PREVOST

WARRANTY BULLETIN

Wb11-17A

DATE : MAY 2011	SECTION : 18 - Body
EXPIRATION: MAY 2013	
SUBJECT : JAMMED LATCH – RADIATOR DOOR AND DPF ACCESS DOOR

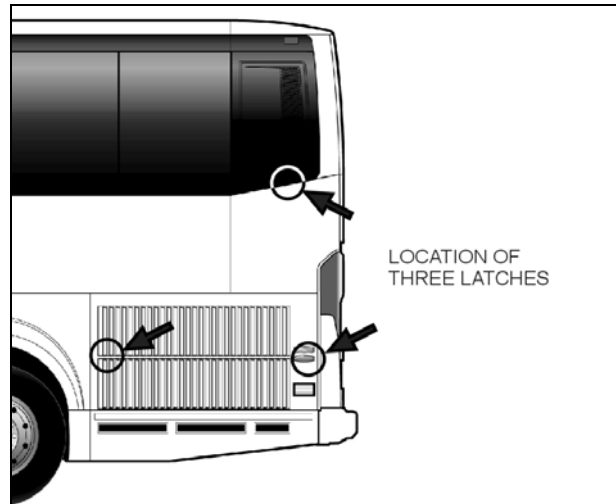
On the vehicles affected by this bulletin, it is necessary to check the radiator door latches (2) and the DPF access door latch (1) for proper functioning.

FAILURE CAUSE: The faceplate hole may be slightly out of round or too small.

FAILURE CONSEQUENCE: Jamming of the latch bolt into the faceplate is likely to happen, preventing the latch bolt to return to its normal position with the spring action once the door is closed. As a result, the door may give the impression that it is properly closed and secured. The door could open by itself while the vehicle is traveling.

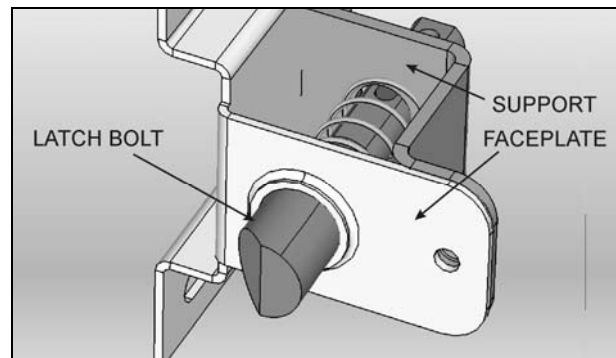
1. Locate the three latches with the image on the right.
2. Open the radiator. Locate the two radiator door latches.

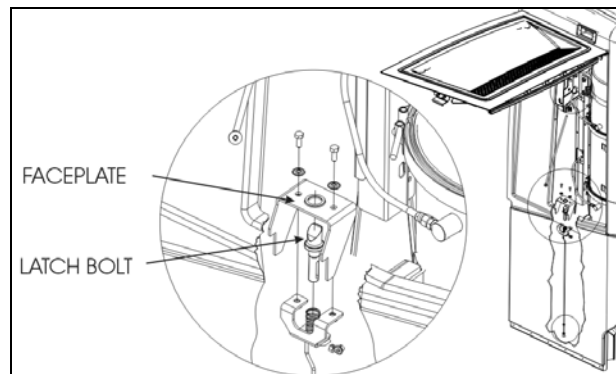
3. Check that there is a small play between the latch bolt and the faceplate. Validate that the latch bolt can move freely and that it returns to its normal position with the spring action when released. If the latch functions properly, no repair is required.

4. Proceed to the same verification for the DPF access door latch.
5. If the latches do not function properly, repair as follows.
6. Dismount the support, remove the latch bolt and enlarge the faceplate hole slightly using a $\text{Ø}3/4$ inch ($\text{Ø}19\text{mm}$) reamer or drill bit.
7. Reinstall the latch, apply a thin coat of lubricant and check for proper functioning.
